UCL - CLOE Main Works – Quest NMA Information – External Grilles

UCL - CLOE Main Works – Quest NMA Information – CHW Riser

Photo of rear elevation showing area where pipework had to deviate from consented drawing

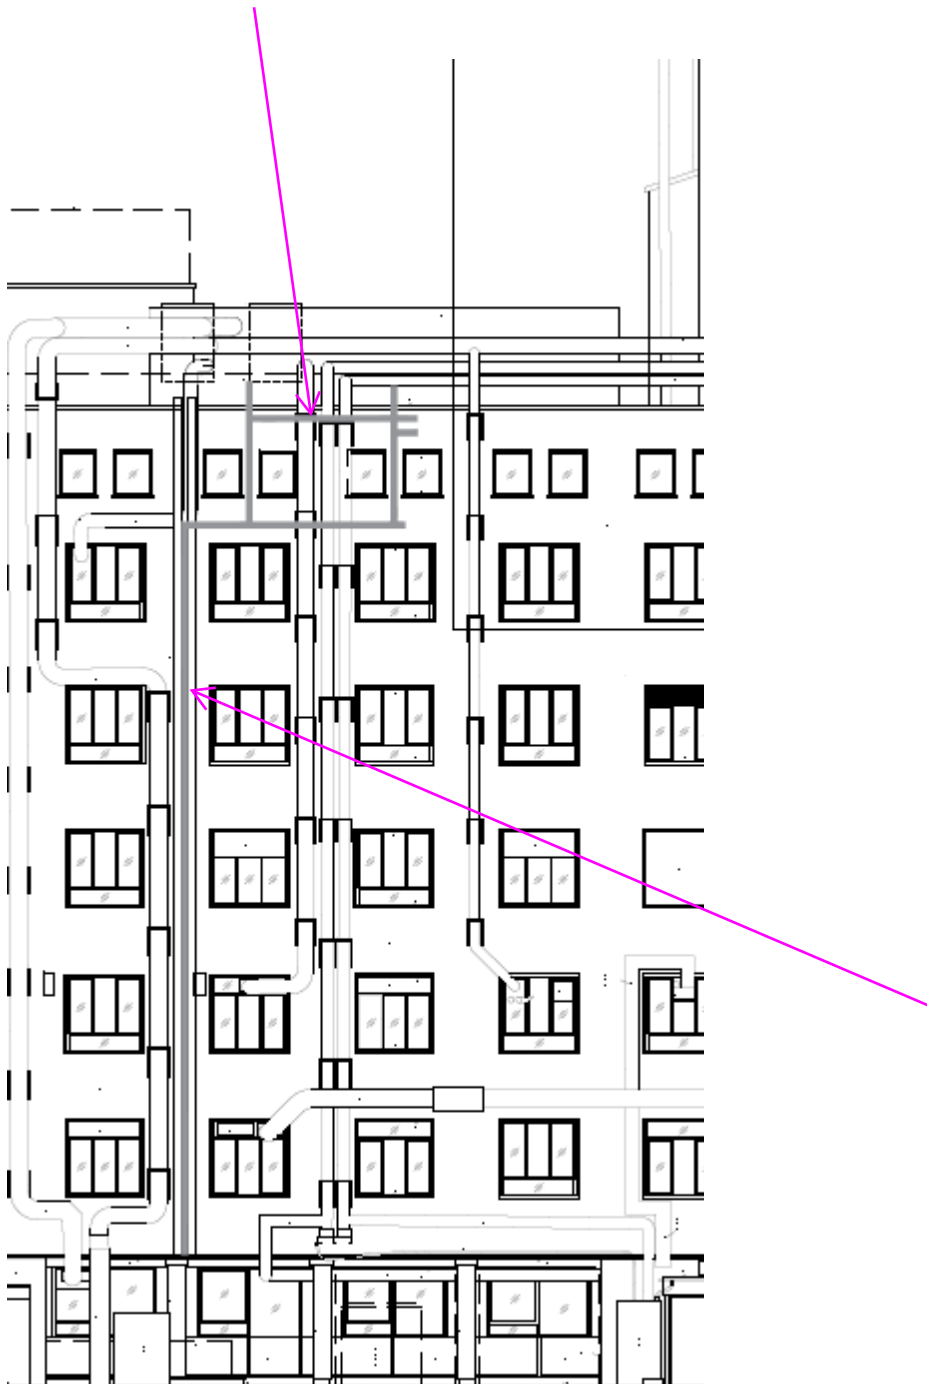
New pipework shown in Grey on updated planning drawing

As installed – new grilles/louvres to lab spaces shown in below locations - EL1, EL2, EL3, EL4

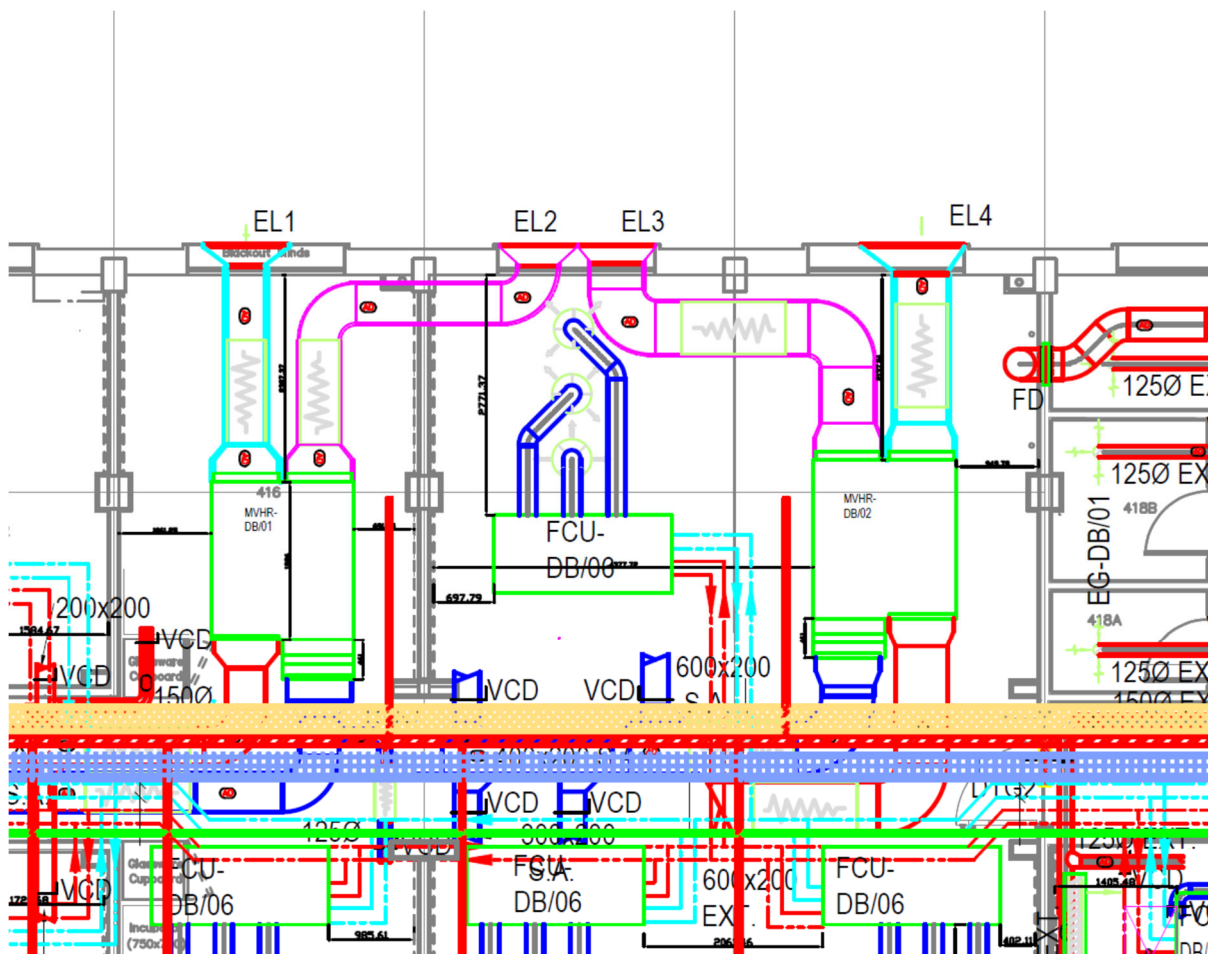
Plenum for grille has had to be installed externally in order to achieve the internal design as per drawing and photos below. Hence grille is on outer face of window.

Meeting Room 422 - Tender/ S3 design

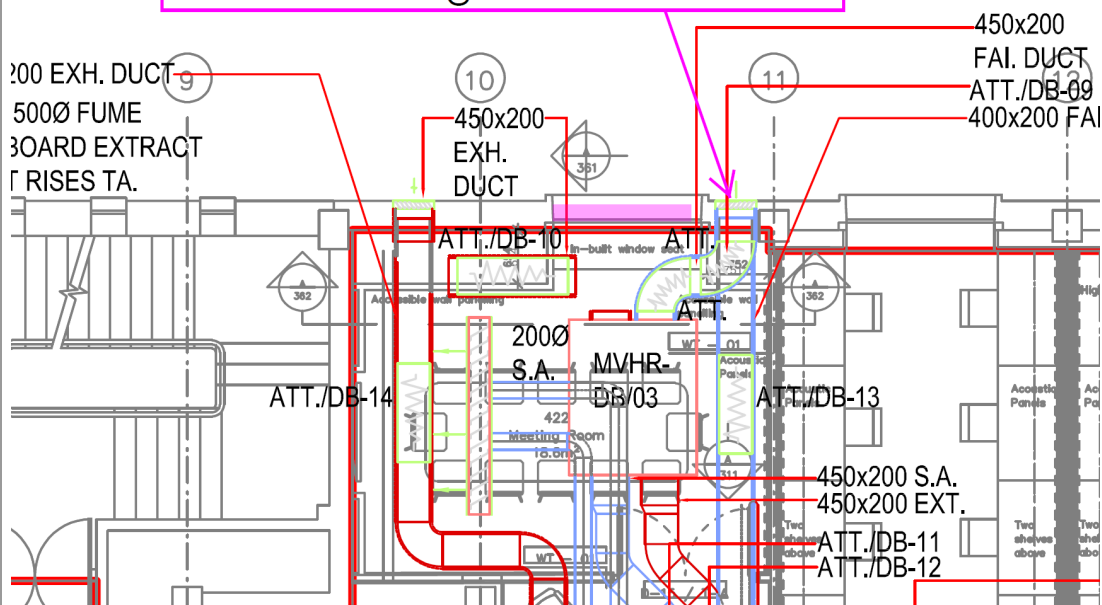
Tender design shows grille in external face of brickwork, however internal space isn't adequate for attenuation. External space between window and structural column is also insufficient for grille in this location

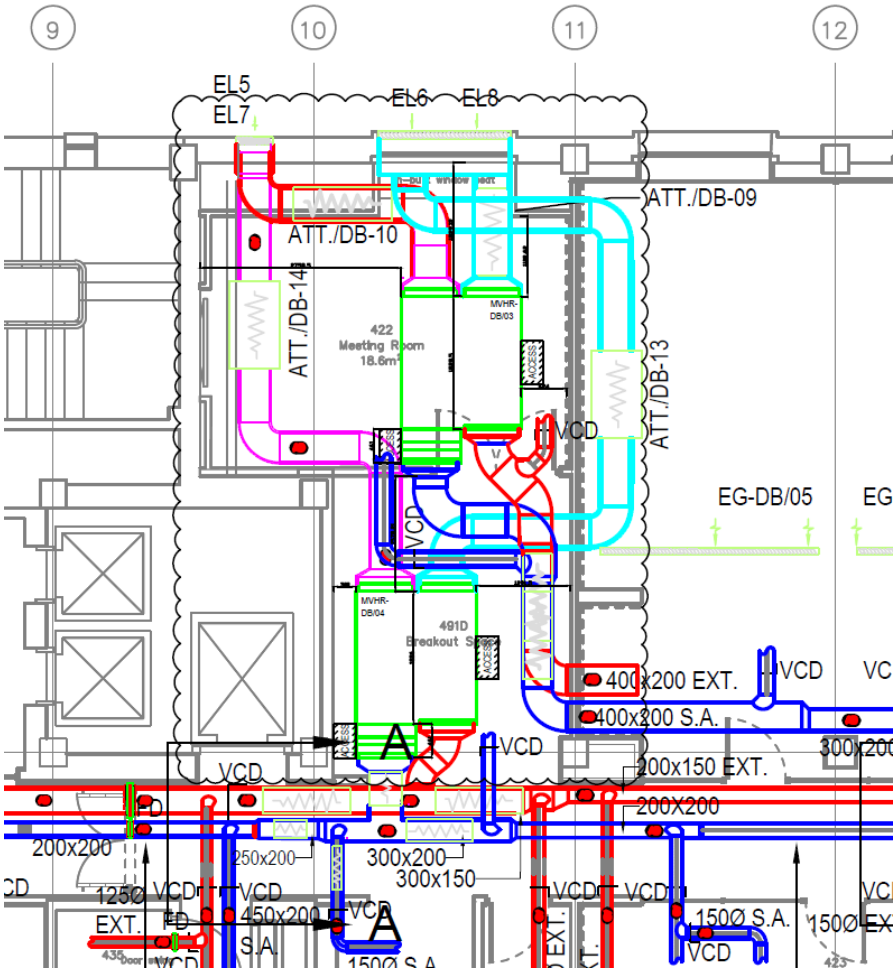
Room 422 - grille EL6 and EL8 are connected onto plenum which is installed externally, allowing for sufficient room internally for ductwork and required attenuation

Chilled Riser Pipework – High level 6th floor

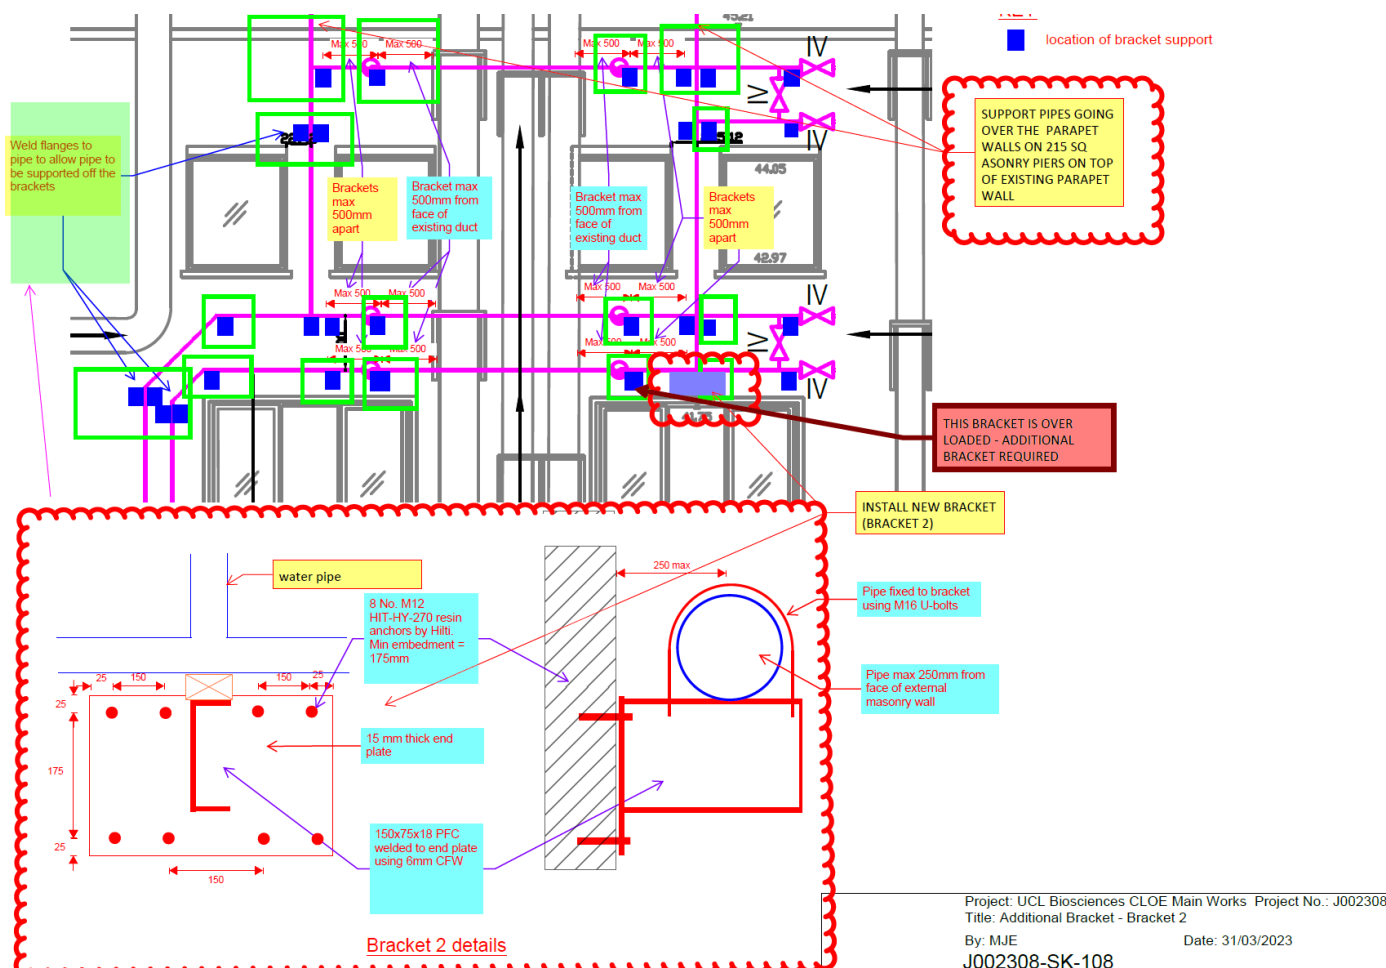
Chilled water pipework shown at 6th floor level supported off new brackets as per structural engineer's specification. Pipework was required to be fed around existing ductwork. Any deviation from consented route is to allow for adequate bracketry and to avoid clashing with existing services
